STATE OF NEBRASKA  
DEPARTMENT OF ROADS  
ADDENDUM NO. 1  
AND  
ELECTRONIC BIDDING SYSTEM  
AMENDMENT NO. 1  
PROJECT NO. STP-275-7(190)  
CONTROL NO. 21574G  
CALL NO. 205  
US-275, SOUTH OMAHA BRIDGE, IOWA  
PEDESTRIAN TRAIL PAVING  
LETTING DATE: MARCH 3, 2011

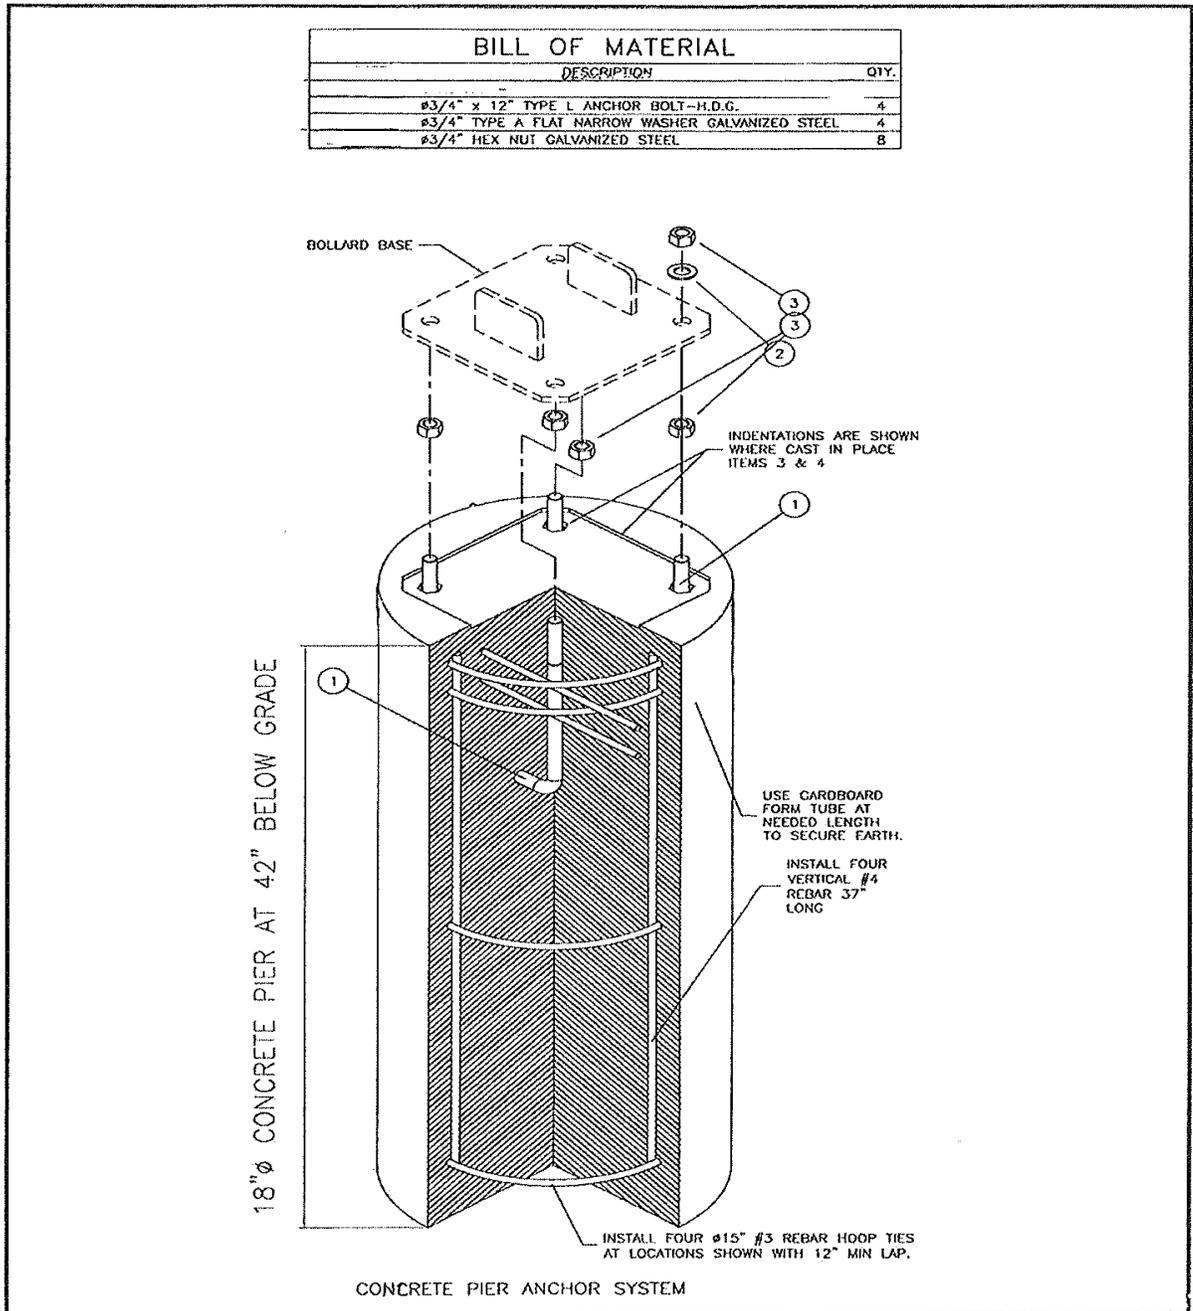
- 3.1.1 Manufacturers Instructions: Comply with manufacturer provided instructions and drawings.
- 3.1.2 Base Units: Base units should be installed with the top plate flush with the finished surface. Be sure to keep any holes in the base unit top clear of taking on any debris that would limit the bollard unit from seating properly per instructions.
- 3.1.3 Bollard Unit: Bollard should be secured to base unit after it is leveled and fully cured.
- 3.1.4 Field Painting: If field painting, be careful not to paint moving parts which may restrict the bollard's proper function.
- 3.1.5 Footing detail is 18" round by 42" deep concrete. Install four #4 rebar and four #3 rebar hoops as shown. The indentation of bollard mounting plate in footing surface as shown. Detail is below.
